Meeting Date:  
July 8, 2019

Location:  
2113 Ravenna Street

Request:  
Site Plan Application

Hudson Planning Commission	SITE PLAN REVIEW
Case No. 2019-485 January 11, 2020	July 2, 2019

**GENERAL NOTES:**

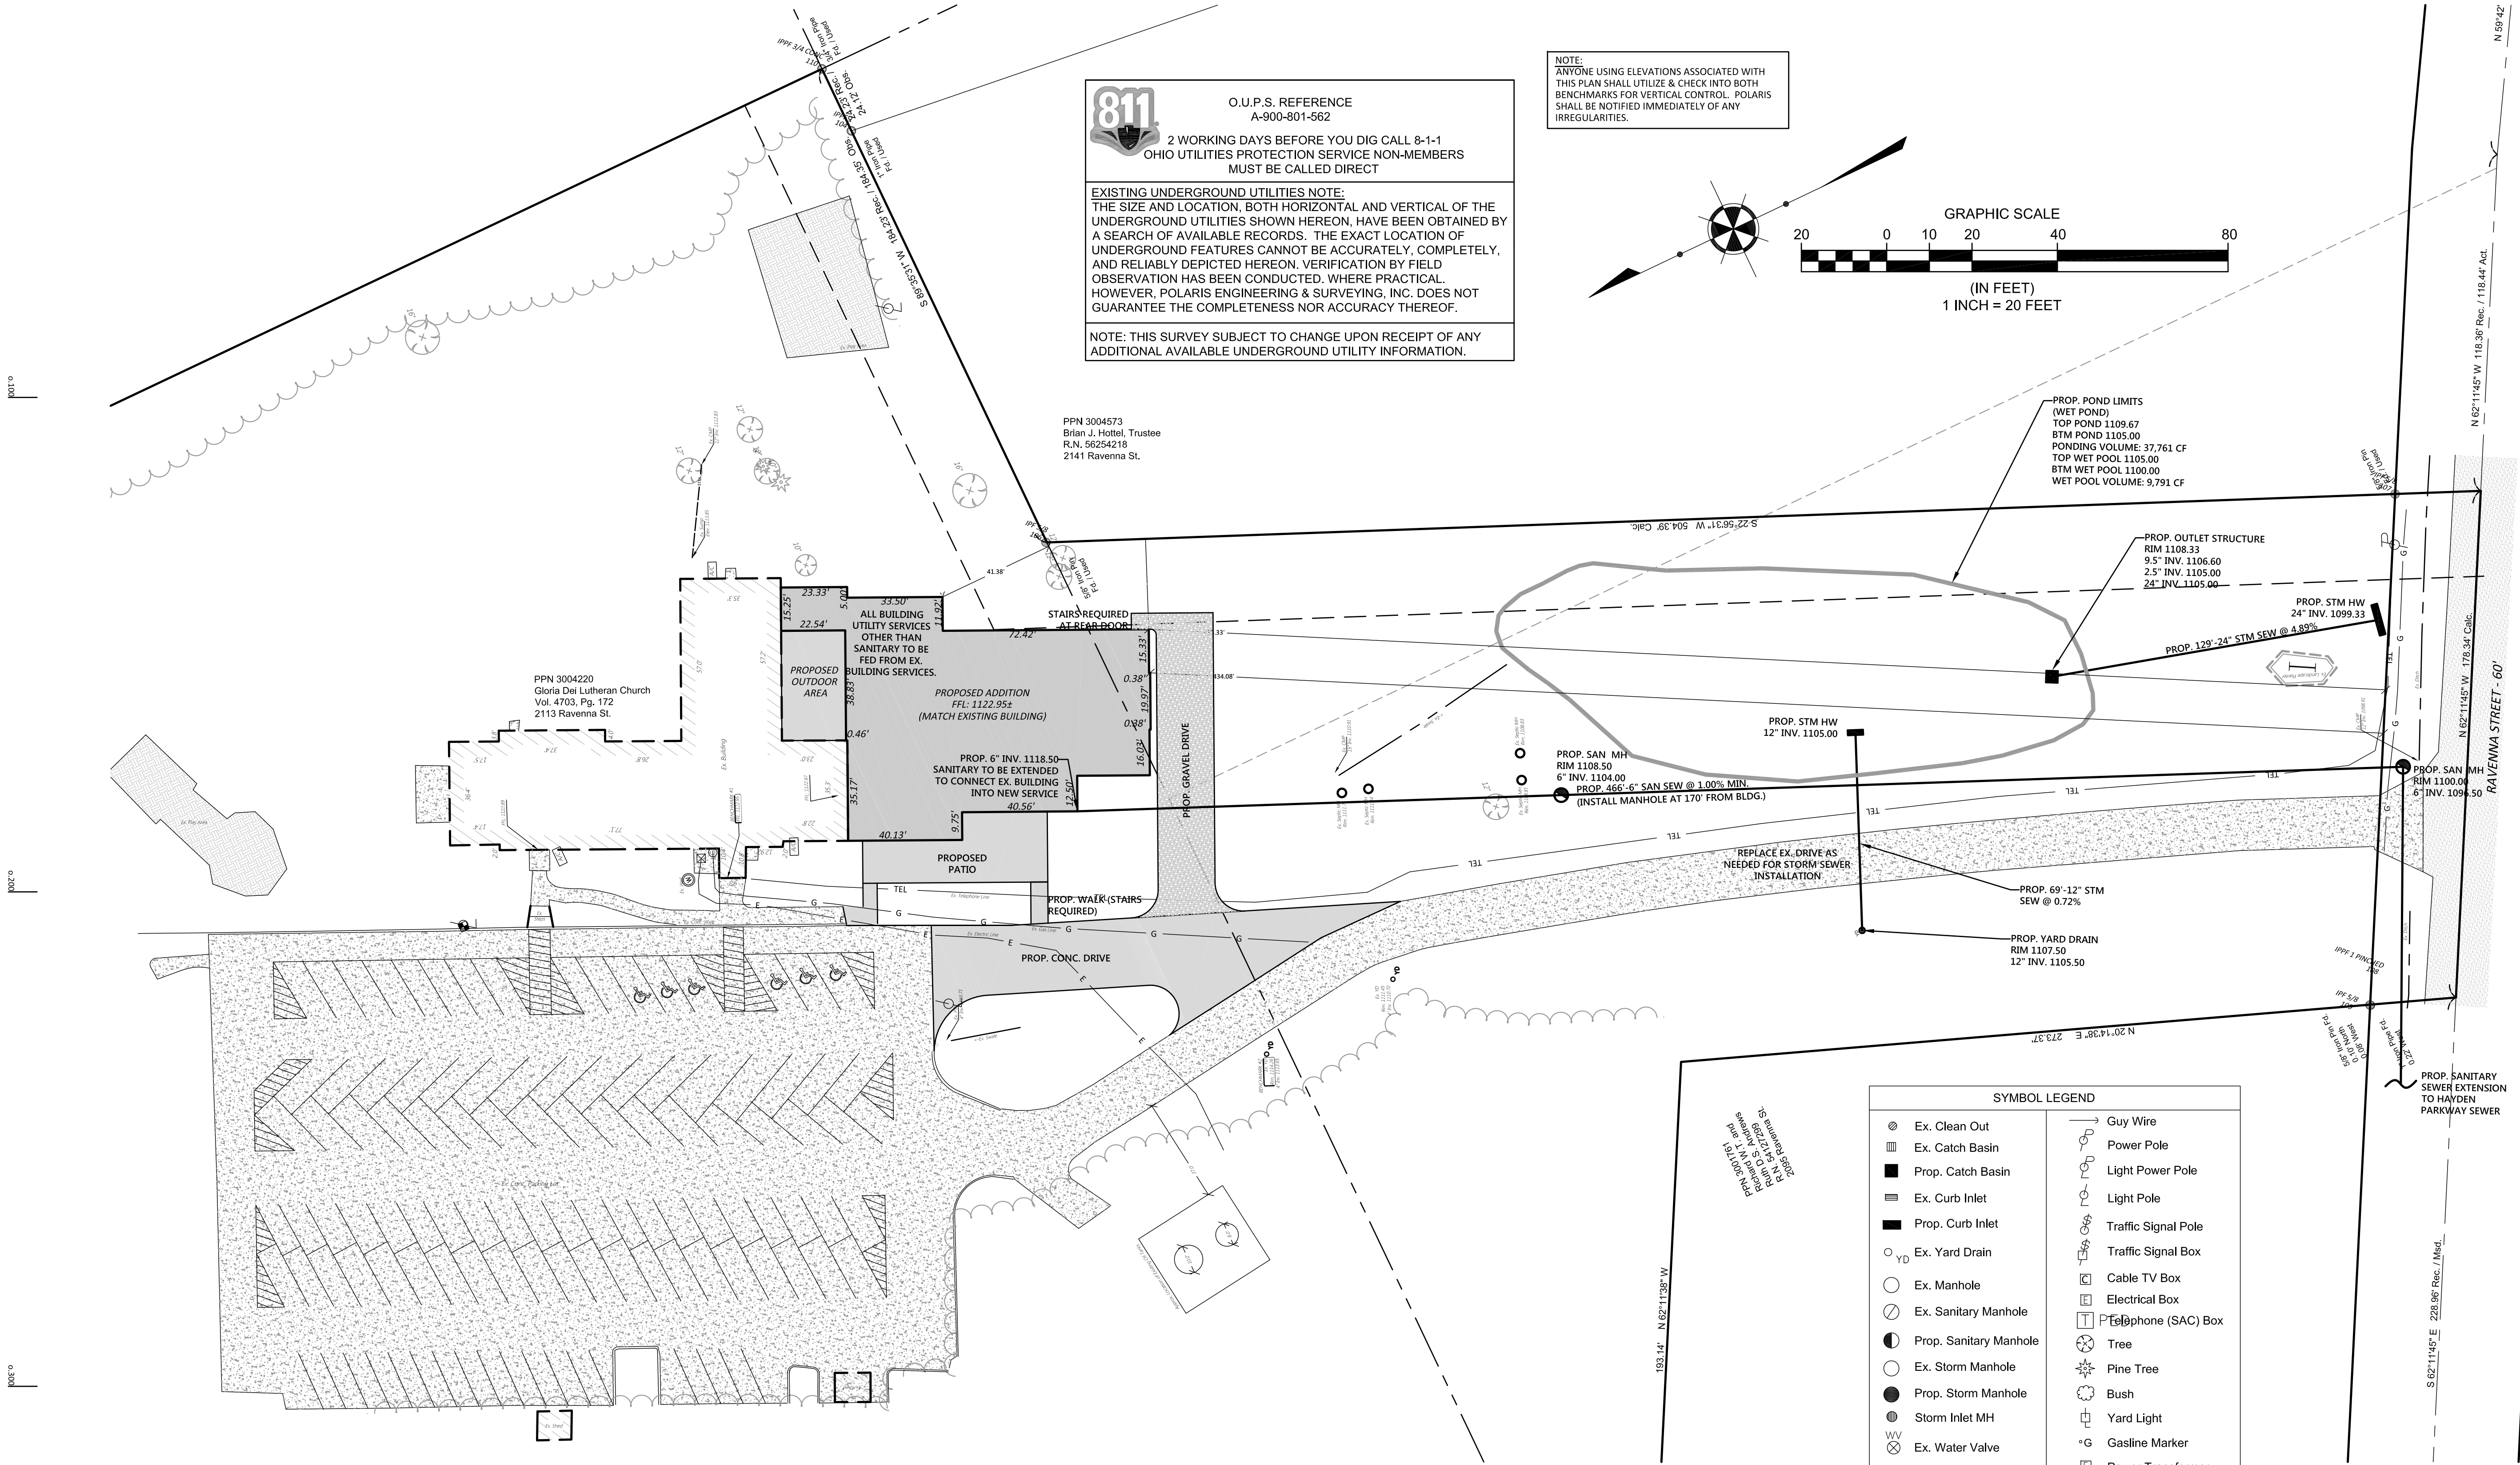
- ☐ **Landscaping** Bufferyard D (25 feet) is required. Add landscaping along east side of building addition and approximately 150' south of the playground. (condition 2)

1. Side yard buffer will include + 30' of seeded lawn and existing landscaping along property line. Proposed +/- 20' landscaping bed along southeast corner will be in addition to the seeded lawn and existing landscape along the property line.
2. No new dumpster enclosure proposed. Existing to remain.
3. Existing vegetation (wooded yard +/- 125') around the parking lot to remain to screen parking lot.
4. Civil drawing package is included to meet stormwater management requirements.

ROOF PLAN

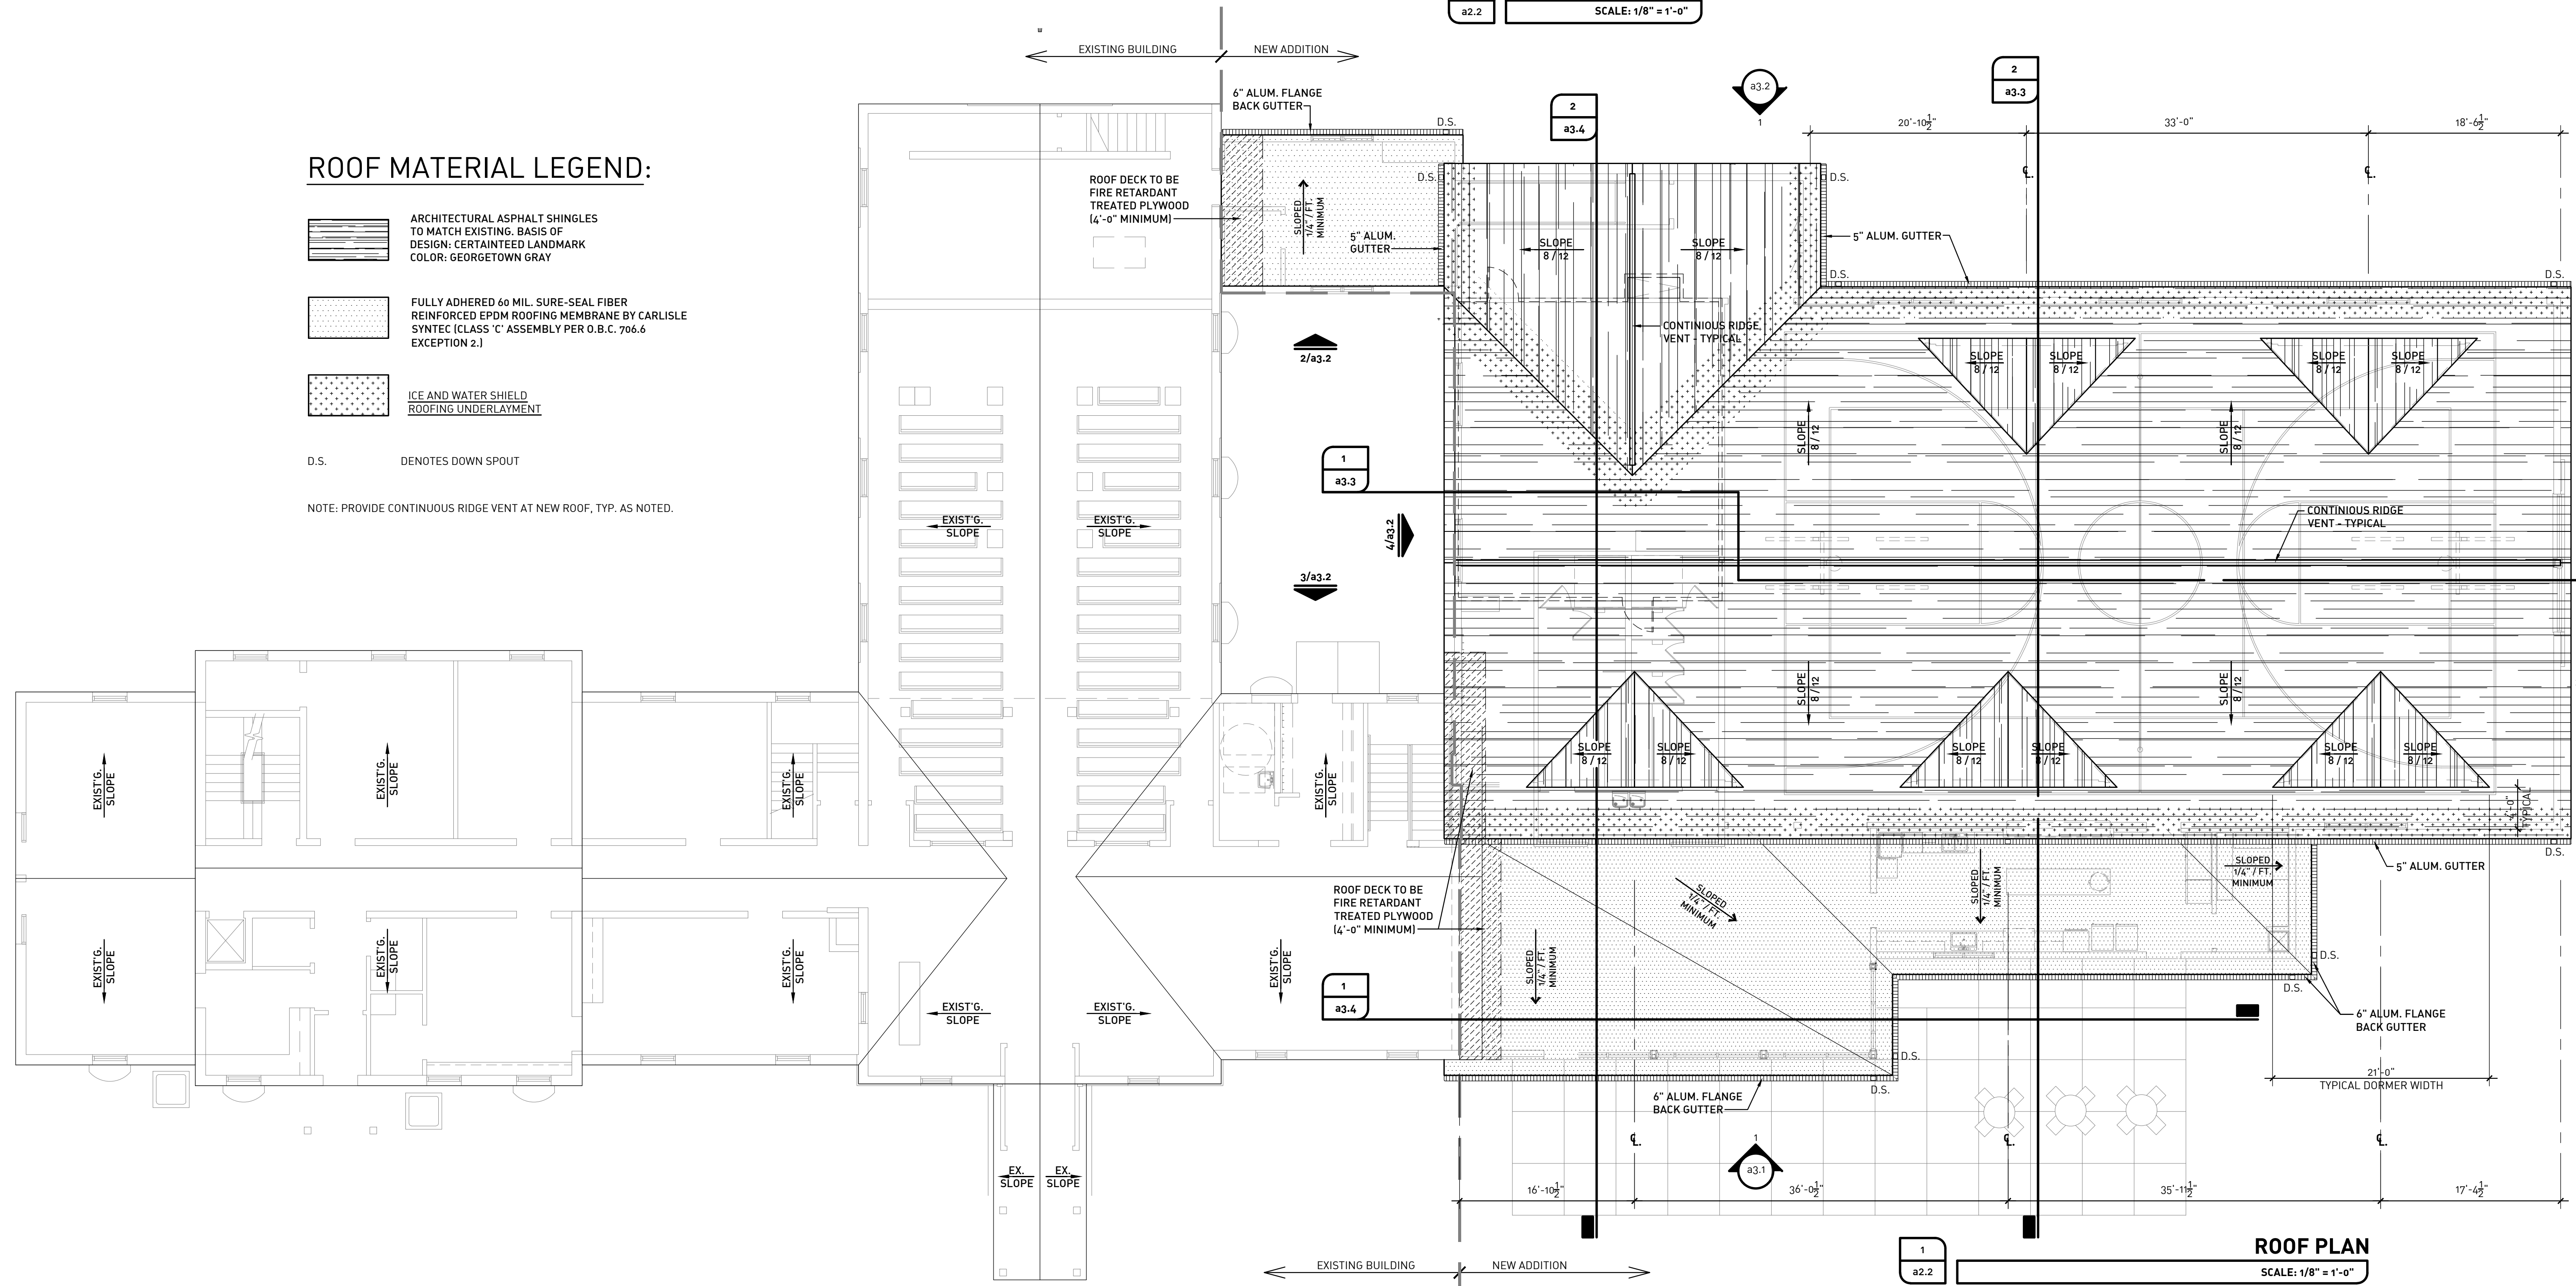
- The front door or main entrance to a building shall be visible from the street. An entrance to a public building shall be clear and visible from the street and not obscured by building masses or fences. Staff notes the addition conceals the existing front entrance however the building does contain a significant setback from the street.
- The addition is taller and more dominant than the existing mass. It is also attached to the front of the building, which conflicts with our requirements for wings. Could the addition be considered a main mass if a front entryway is added (a requirement of the main mass)?
- Question if the long span of roof can be broken up with reverse gable or dormers similar to the existing?
- Suggest using additional brick surfaces to match the existing structure.
- Submit a roof plan to better understand how the masses relate to each other.
